UNITED STATES PATENT AND TRADEMARK OFFICE

| APPLICATION NO. | FILING DATE | FIRST NAMED INVENTOR | ATTORNEY DOCKET NO. | CONFIRMATION NO. |
|-----------------|-------------|----------------------|---------------------|------------------|
| 10/533,663 | 05/03/2005 | Naohide Wakita | 10873.1677USWO | 6214 |

Office Action Summary

DETAILED ACTION

**FIG. 1a****FIG. 1b**

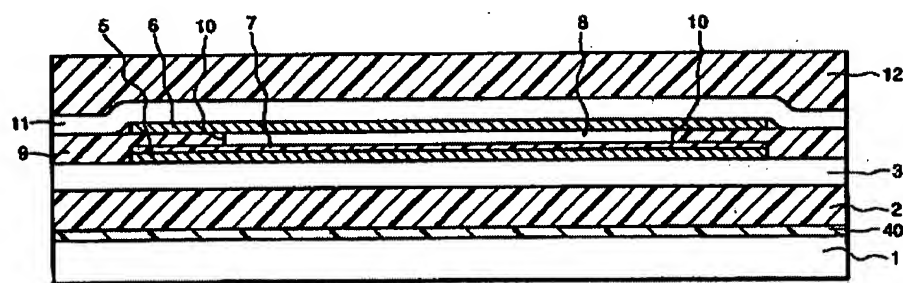
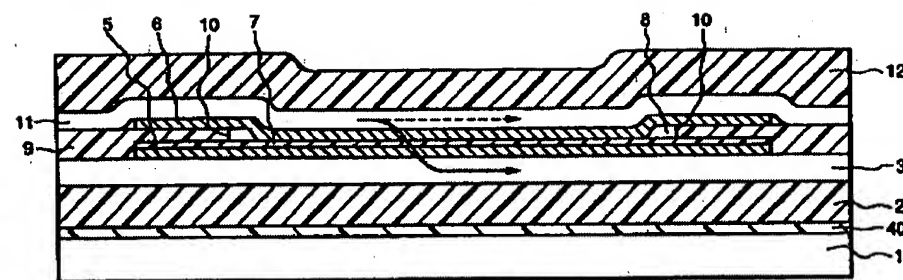
In re claim 1, Ghezzi discloses a display element (e.g., see Figures 1a-1b) comprising a light source for providing light and a waveguide that comprises a deformable core 11 that propagates a light emitted from the light source, wherein the light propagated in the waveguide is extracted to outside from a waveguide lateral face,

the display element further comprising a plurality of actuators 5/6/7 that deform a shape of the waveguide,

wherein the actuators 5/6/7 are operated selectively to deform a surface shape of at least a portion of the core 11 on the waveguide lateral face to a concavo-convex shape so as to change a reflection direction of light propagated in the waveguide thereby *inherently* extracting light out of the display element from the waveguide lateral face. Figures 1a-1b of Ghezzi are reproduced below.

In re claim 3, the waveguide comprises a cladding 8/9 formed along one lateral face of the core 31, wherein the actuators 5/6/7 are attached to the cladding 8/9 and the shape of the waveguide lateral face is changed by deforming the actuators.

In re claim 9, the actuators comprise: an electrode film 6 arranged at the waveguide lateral face, and an external electrode film 5 that is in opposition to and adjacent to the waveguide, wherein the shape of the waveguide lateral face is changed by an electrostatic force produced by applying a voltage between the external electrode film 6 and the electrode film 5.

In re claims 11-12, the waveguide core 11 is elastic and deforms to extract light out of the waveguide as seen in Figures 1a-1b.

Fig. 1

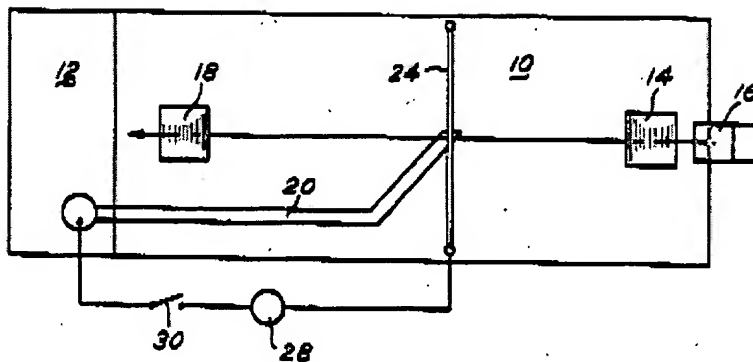
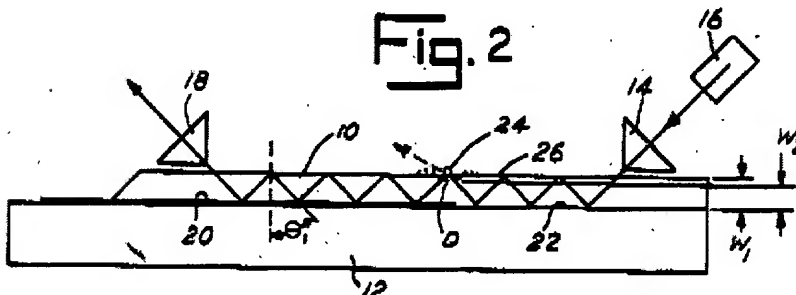
In re claim 1, Conwell discloses a display element (e.g., see Figures 1-2) comprising a light source 16 for providing light and a waveguide that comprises a deformable core 10 that propagates a light emitted from the light source 16, wherein the light propagated in the waveguide is extracted to outside from a waveguide lateral face 26,

the display element further comprising a plurality of actuators 20/24 that deform a shape of the waveguide,

wherein the actuators 20/24 are operated selectively to deform a surface shape of at least a portion of the core 10 on the waveguide lateral face to a concavo-convex shape so as to change a reflection direction of light propagated in the waveguide thereby extracting light out of the display element from the waveguide lateral face as seen in Fig. 2. Figures 1-2 of Conwell are

In re claims 8-12, the actuators 20/24 comprise a round electrode film/filament 24 arranged at the waveguide lateral face and comprising a convex portion; and

an external electrode film 20 in opposition to and adjacent to the waveguide

wherein the shape of the waveguide lateral face 26 is changed by an electrostatic force between the films 20 and 24 and pressure to the waveguide lateral face with the convex portion is made by using the electrostatic force;

and the pressure causes the waveguide core 10 to deform and the core is an elastomer (see columns 2-3).
